SUBJECT: Revised Preliminary Subdivision Plan Approval for the single-family residential Open Space Conservation Subdivision known as the Reserve at River Oaks, Phases I-V.

PC Case No: 2018-5349

RE: The Reserve at River Oaks Subdivision – Phase 4
Revised Exhibit and Engineers Estimate

Date: December 3, 2018
To: Kris McMaster, City Planner
C: Greg Hannan, Director of Community Development
From: Bradley Kosco PE., PS., City Engineer
Re: **Reserve at River Oaks Phase 4 – Revised Cost Estimates for Proposed Waterline and Path Improvements**

TOTAL: \$625,610.94

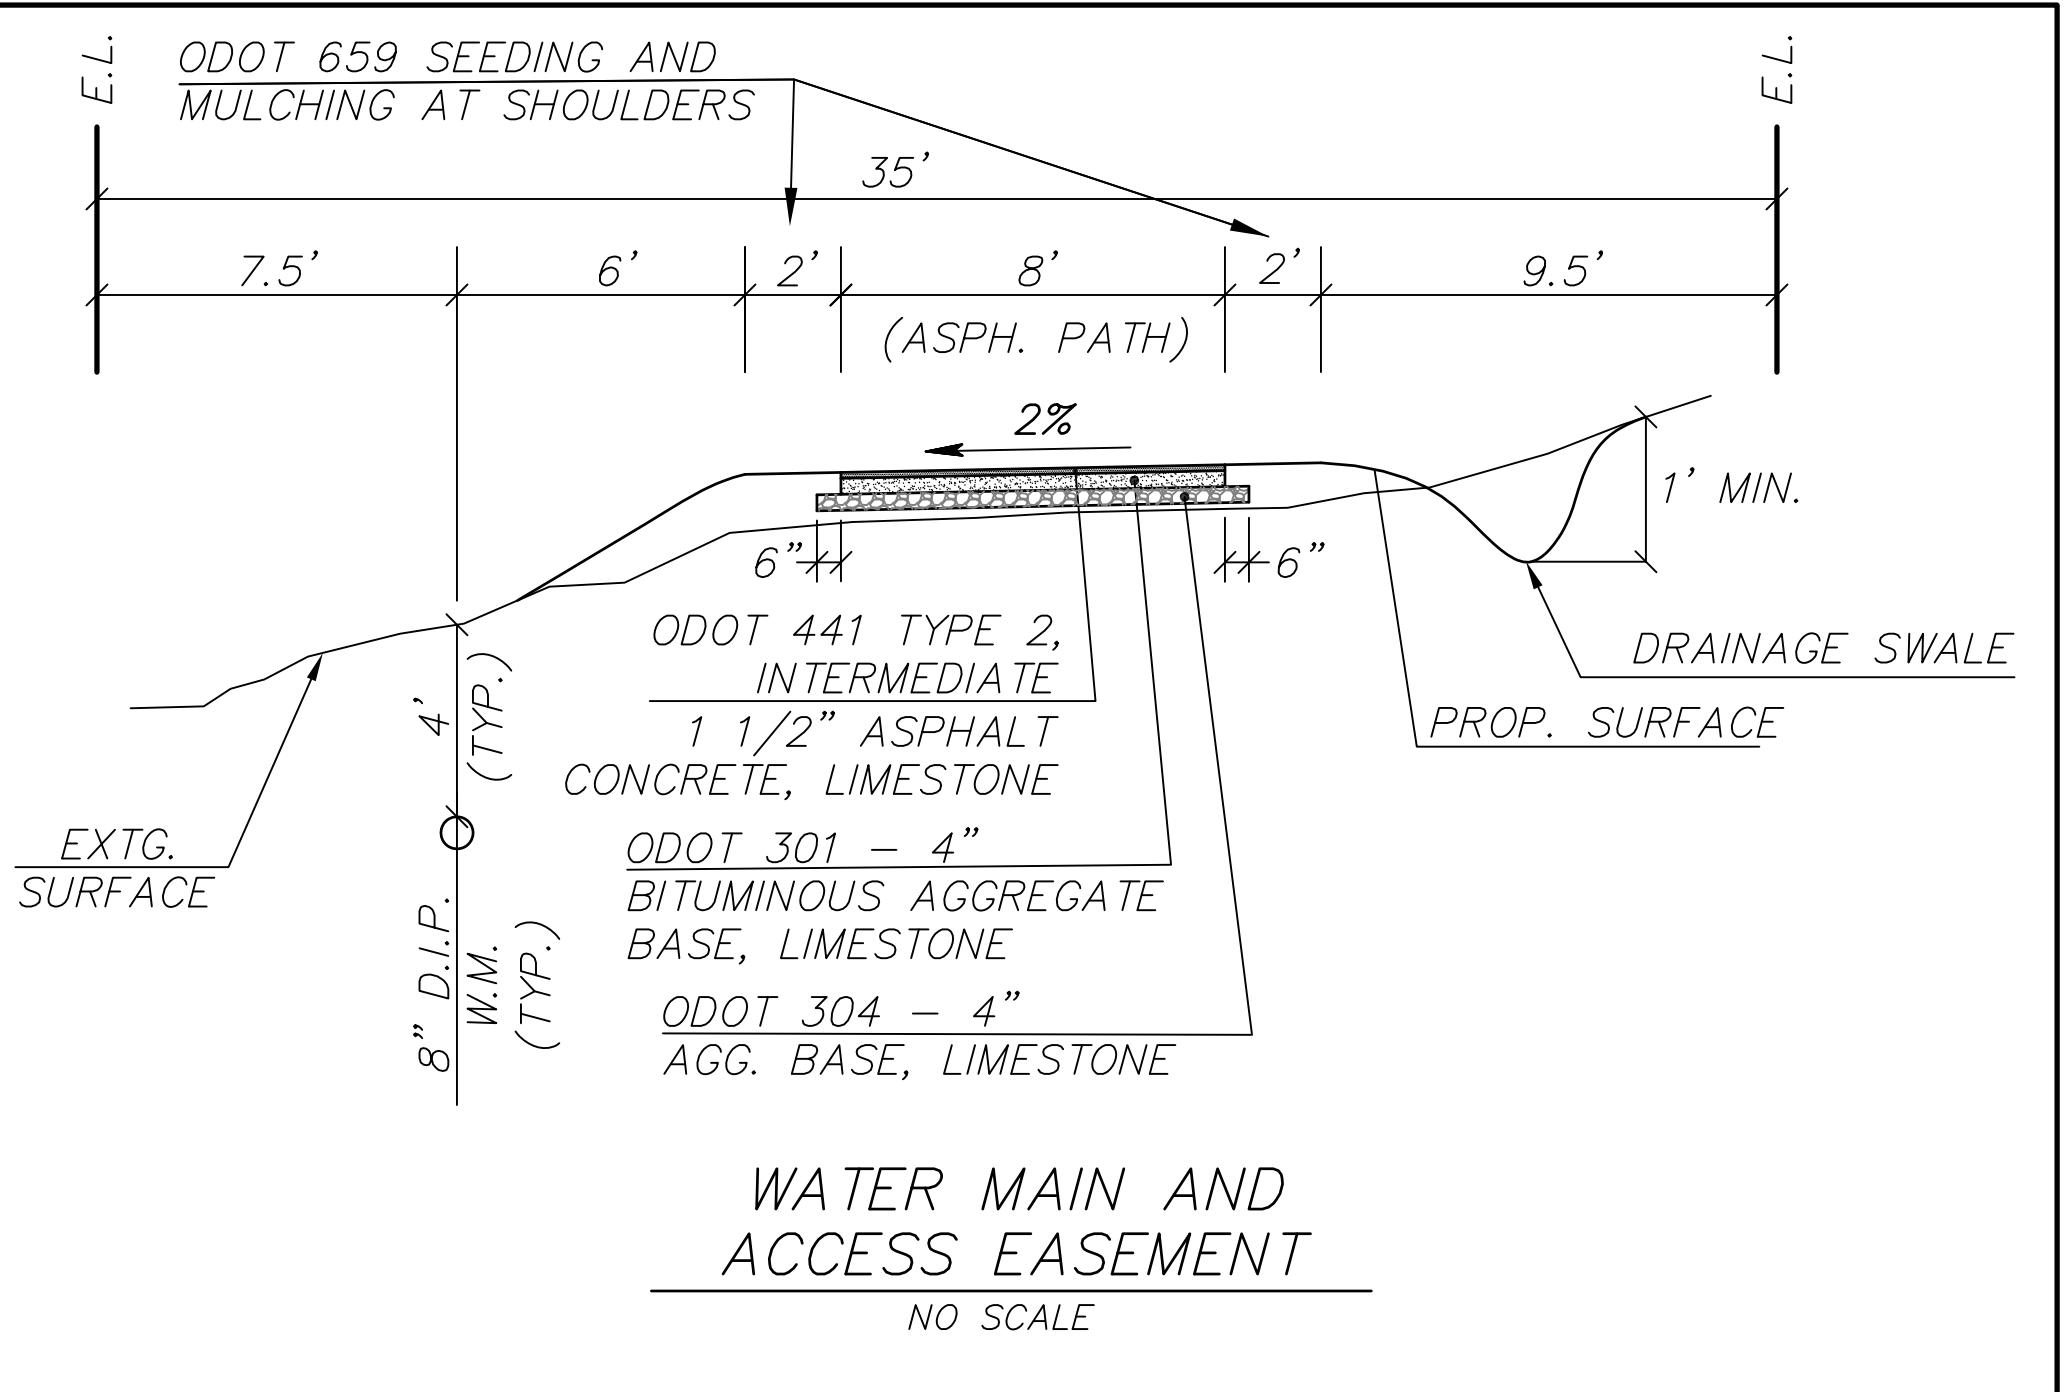
1. Pavement – The City's typical pavement build up (Drawing 7.1.5) for walking paths is attached and will need incorporated into the cost estimate.

2. Waterwork – Verify any high spots on waterline alignment (no labels on contours). Blow-off assemblies will be required at high spots.

3. Waterwork – Mainline water valves are required a min. 500 foot intervals (10 State Standards). At 2,900 LF of waterline, a min. of six main valves would have been required for the connection between properties.

4. Waterwork – Is Dewatering accounted for anywhere?

5. Miscellaneous – Add an inflation cost increase of 3.9% (ODOT projected rate) for 1 year (i.e. Construction Cost Estimate = $\$580,000 \times 0.039 \times 1 = \$22,500+1$). I suggest one year because Pulte would have likely installed some/most of infrastructure within next 12 months).
Per the provided ODOT documentation, a 4.8 percent inflation rate was applied to the total engineer's estimate. For an estimate total of \$596,957, 4.8 percent would be \$28,653.94, for a total engineer's estimate of \$625,610.94.

6. Notes – Please forward a copy of the “Davey Estimate (2)” outlining the terms of mapping, reporting, permitting for a cost of \$68,500.
An updated copy of the cost breakdown from Davey has been included, which has an estimated cost of \$96,700.

1. The plan should have included cost to jack and bore casing pipe to avoid wetland disturbance for future maintenance (similar casing pipe install planned for water connection between Hudson Crossing Parkway and River Oaks 3). Please comment.
The engineer's estimate and exhibit assumed the watermain would be open-cut per the wetland permitting. The Davey estimate was updated for category 3 wetlands and the cost increased from \$68,500 to \$96,700.

The path detail on the exhibit was updated per the City's pavement build up and the engineer's estimate was revised.

Contour labels were added to the exhibit. One Air release valve is now shown and has been added to the engineer's estimate.

Section 8.3 of 10 State Standards lists 800 foot intervals in non-commercial districts and also states "where widely scattered customers and where future development is not expected, the valve spacing should not exceed one mile." Since there wouldn't be any house connections on the circulation main from River Oaks Phase 4 to Phase 5, the main would fall under the minimum spacing criteria of one mile. Two additional valves were added to the plan for maintenance convenience to increase the total number of valves from 2 to 4.

The engineer's estimate assumed dewatering was included in the price of \$63/LF.
